Service Bulletin

Bulletin Number: **SB 24-367**
 Release Date: **August 28, 2024**
 Distribution: **Heil Dealers, Heil Technical Services, Heil Customer Care**
 Subject: **CNG Solenoid Removal**

This Service Bulletin outlines the process to remove the CNG solenoid.

Figure 7

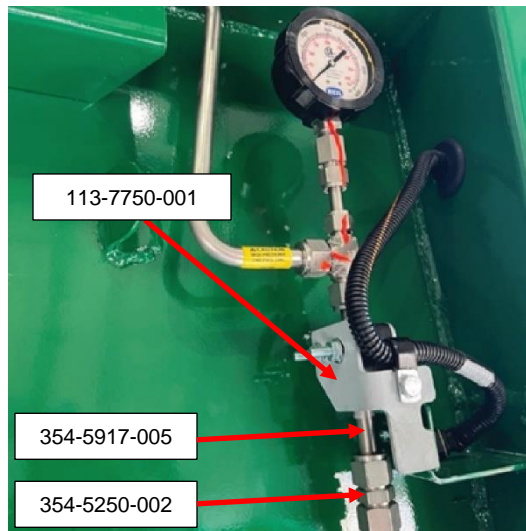
- O. Disconnect, remove, and discard the short tube above the solenoid valve.
- P. Disconnect the lower tubing from the solenoid, then remove the solenoid from the bracket using a 10mm wrench.
- Q. Place the replacement tube **354-5917-005**, coupler **354-5250-002**, and hand tighten.
- R. Install bracket **113-7750-001** on the existing solenoid bracket with proper hardware shown in **Figure 7**. Place the Stauff clamp **036-1999-003** on the **113-7750-001** bracket and line up the clamp with the tubing. Minor adjustments to the bracket may be necessary to achieve alignment. Verify the clamp does not interfere with Swagelok nut. See **Figure 7**.

Figure 9

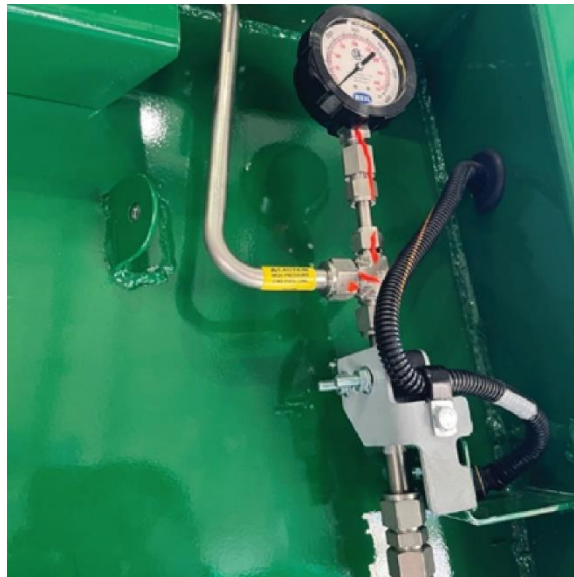
W. See **Figure 9** for final product reference.
